Subject: Revised Application. Rancho Murieta Properties LLC, 3/20/2022

Thank you for meeting with Tom Hennig, Michael Fritschi and myself concerning PNL2014-00206 submitted by Rancho Murieta Properties LLC. Tom will follow up with a summary that will include our discussion concerning the commercial area that has been added to the plan. This letter summarizes my specific concerns that we discussed today.

FIGURE 4

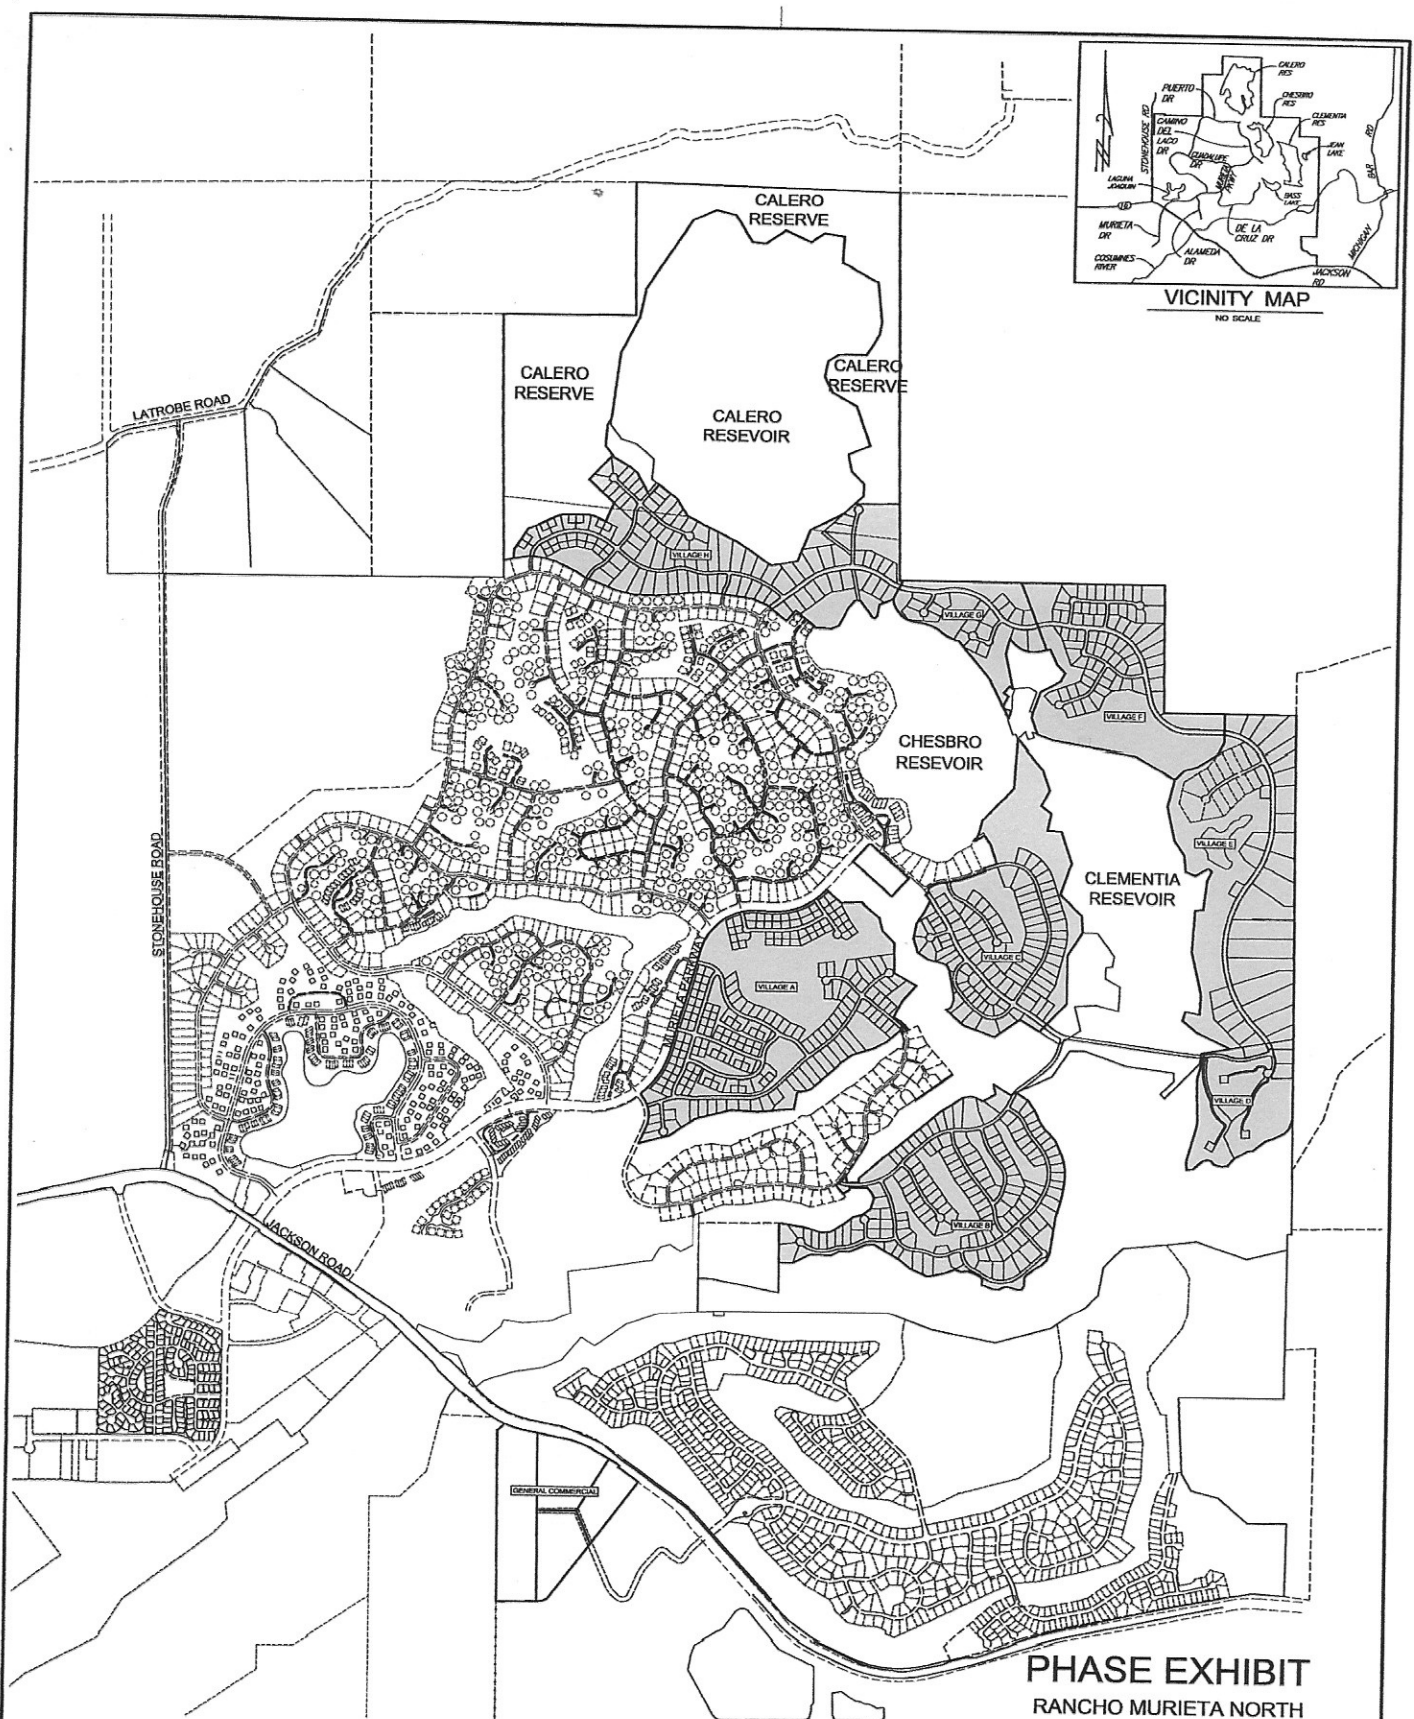
Village D, E, F and G contain a two lane road that connects them to a point of ingress and egress. There is NO alternate escape route from these villages in case of fire or other emergency. Access across the earthen dam at Lake Clementia should be prohibited. Again, without a water engineering study, it is impossible to measure the flow rate and pressure of the water supply in these "outback" regions of the development. How can we be sure significant water pressure and infrastructure construction exist that would make these developments feasible? Will a gravity feed water tank be necessary to service this large expanse of property? Where can it be located? Again, there is no technical study to support the feasibility of the project. Please do not ask us to evaluate the project without complete technical information.

Rancho Murieta has consistently been the home of a pair of American Bald Eagles. These Eagles consistently live at the same location and when necessary, have rebuilt nests in the exact same location. The current mapping of Village E contains proposed lots that interfere with the nesting pattern of these birds. While the developer promises to leave these lots dormant while Eagles are present, this is inconsistent with the permanent nesting patterns of these birds. It is recommended that these lots be permanently dedicated as wildlife habitat. When combined with sensitive habitat for nesting water birds and the presence of cattle at the property lines of each residential dwelling, Village E remains extremely problematic. Fish and Game should be asked to comment on this specific area in its technical study. The EIR should not proceed until this is completed. The removal or retention of these lots will impact the water, sewer and drainage studies required in this area.
